# RE-ENVISIONING NORTHGATE MALL

Major Phased Development | DRB Recommendation - 03  
SDCI # 3032055-EG (MPD # 3031301)  
03 June, 2019 - Meeting Date  
Planner: Brandon Cummings

## BUILDING H1 - HOTEL

## 105TH STREET REVISIONS

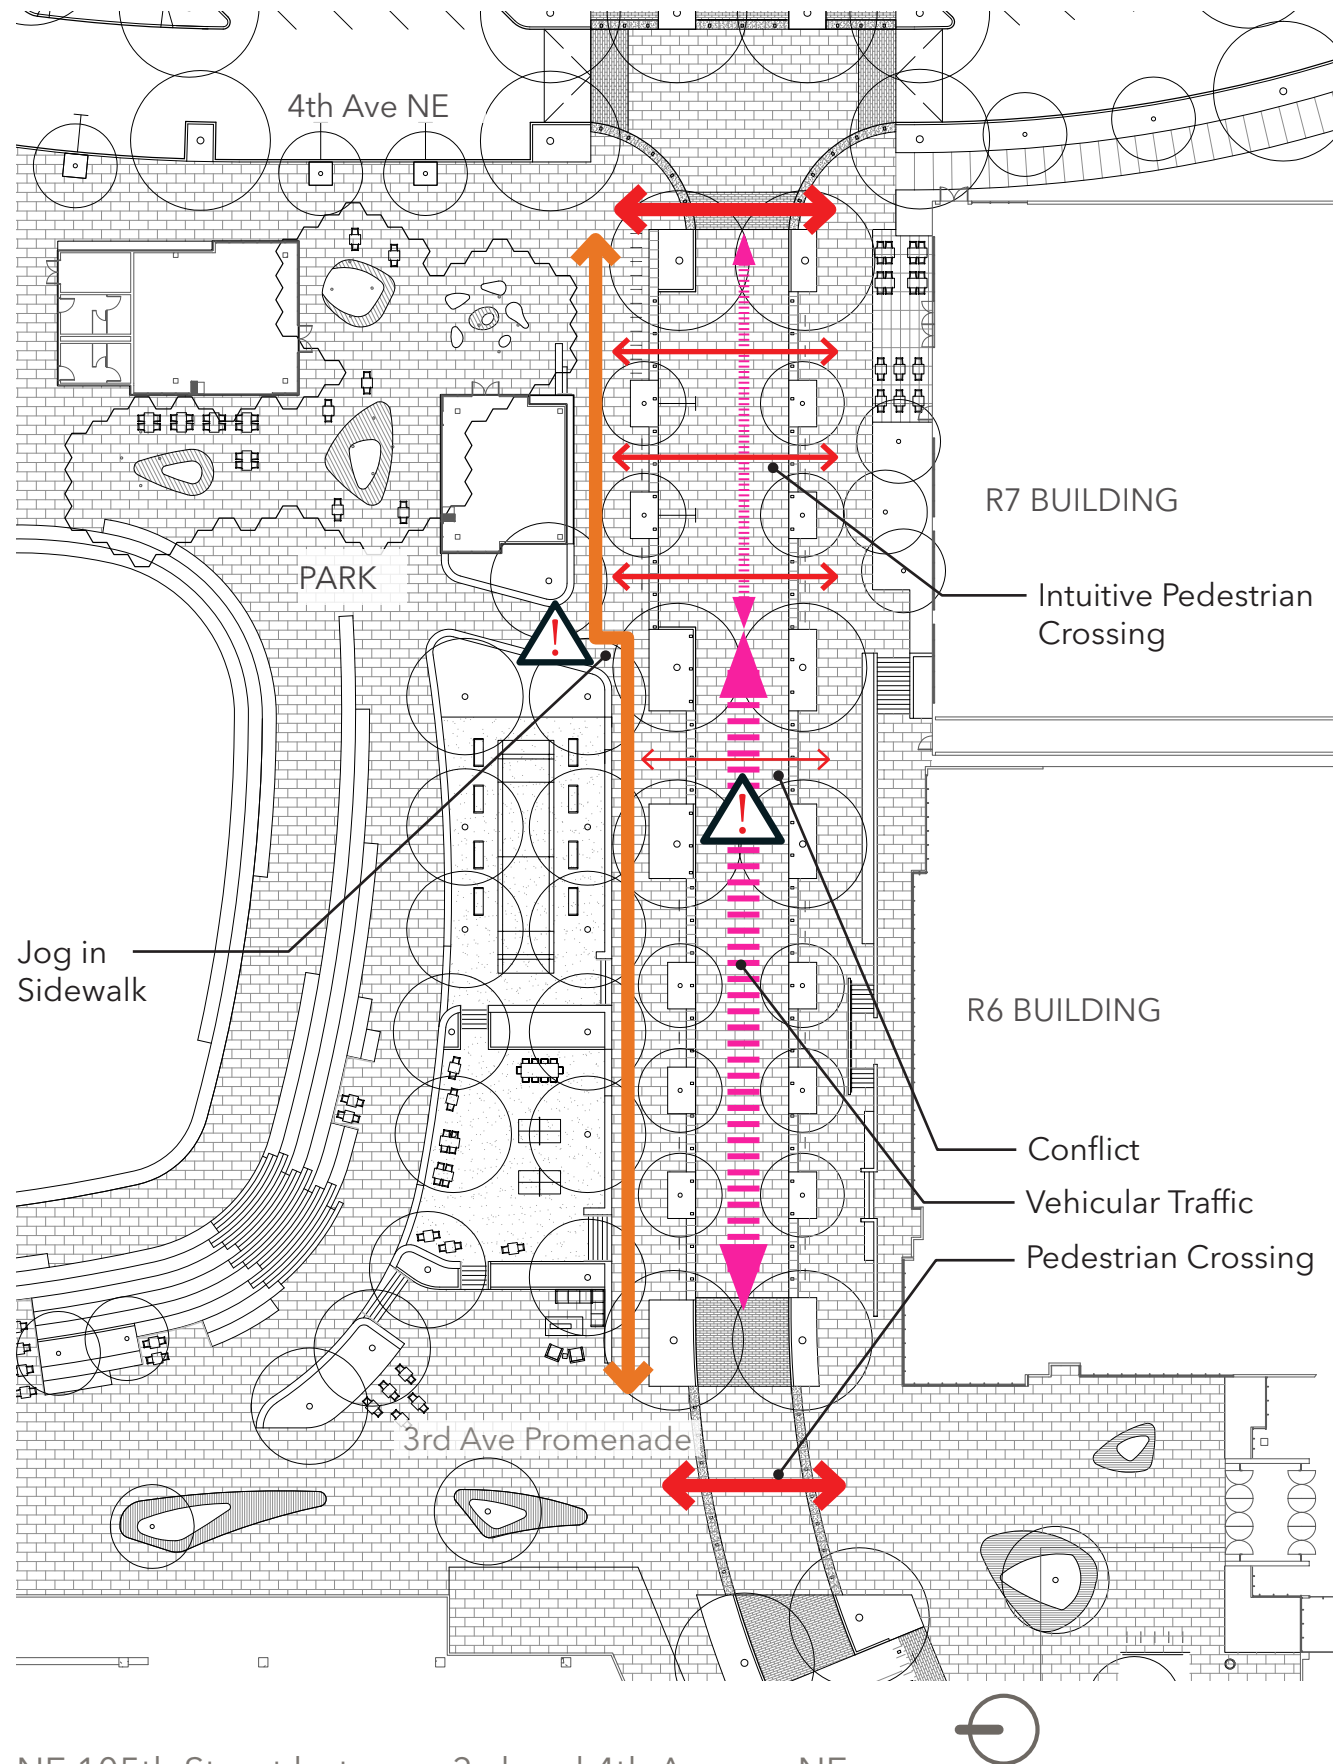
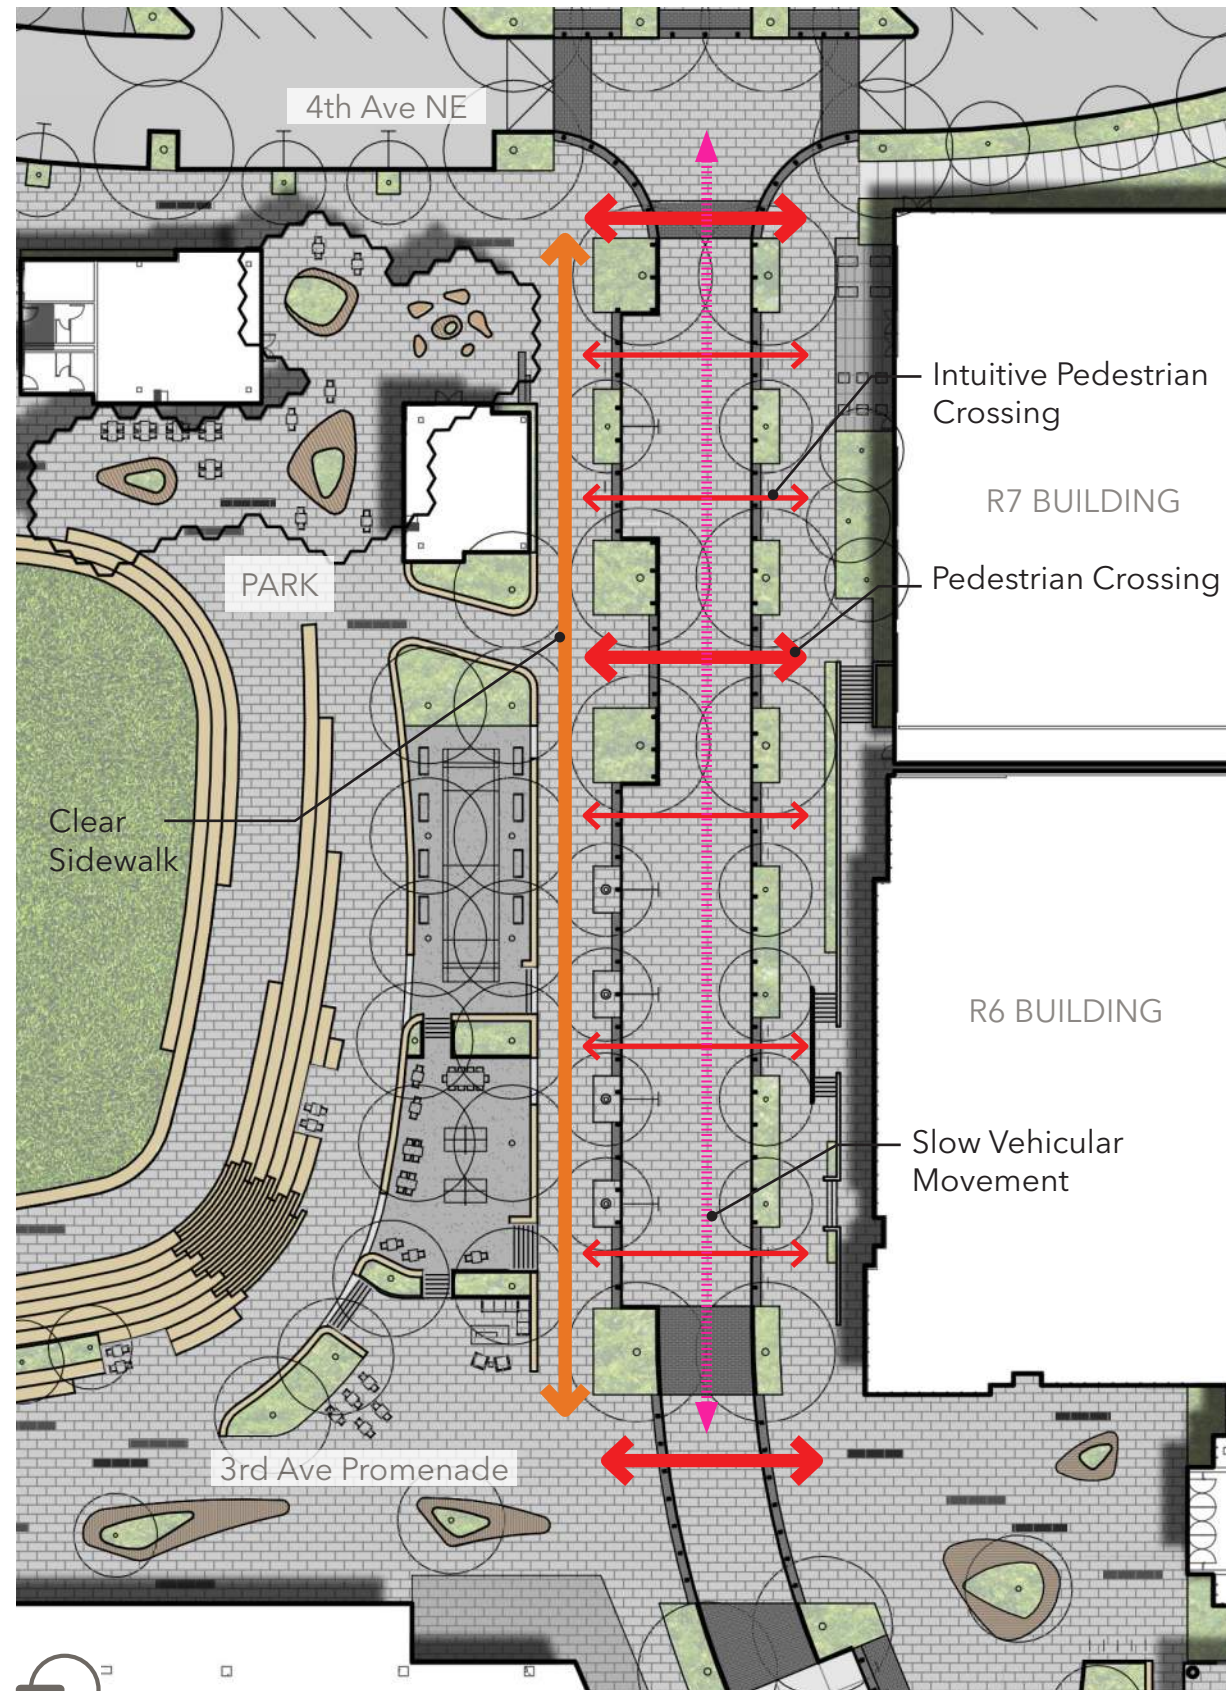
Board Comment: NE 105th Street: The Board supported the design response to the guidance provided at the first recommendation meeting which included extended the pavers across 105th Street to reinforce connectivity to the outdoor terraced areas and build on the concept of the outdoor living room. The Board remained concerned over the presence of parked cars at this location and directed the applicant to consider restricting parking or moving the parking to the south side of the street where the impact is less harmful to the central park. The Board also stressed that if the parking is reduced or moved, active uses should take its place. The Board will revisit the design of NE 105th Street during the discussion for the R6 and R7 Retail Buildings at subsequent meetings."

*Response: The Preferred Option retains the parallel parking to assure 'friction' along the entire block, resulting in traffic calming. The mid-block crossing has been re-aligned to meet the interior uses of the park and the stair connection for the R6 building. Parallel stalls can be used for short-term retail parking, with the western stalls available for food truck use during lunch time on weekdays, weekends, and events. The vehicular movement of short term parking will reduce traffic and allow users a small amount of short-term parking, an incredibly valuable factor in the success of the redevelopment. The short term parking is crucial to street-facing daily use service retail at R6 facing the park that is dependent on easy access and visibility.*

*Food trucks or other flexible parking lane use (such as kiosk, street fairs, etc.) will bring vibrancy and liveliness to the street and the south edge of the park. Patrons using the food truck options will be able to sit in the park, either close by or further in. Planters have been adjusted to provide more planted areas on the street, and crossing areas for pedestrians, bolstering the overall street experience. Planters where food trucks may park will have a tree grate for better use of the sidewalk edge.*
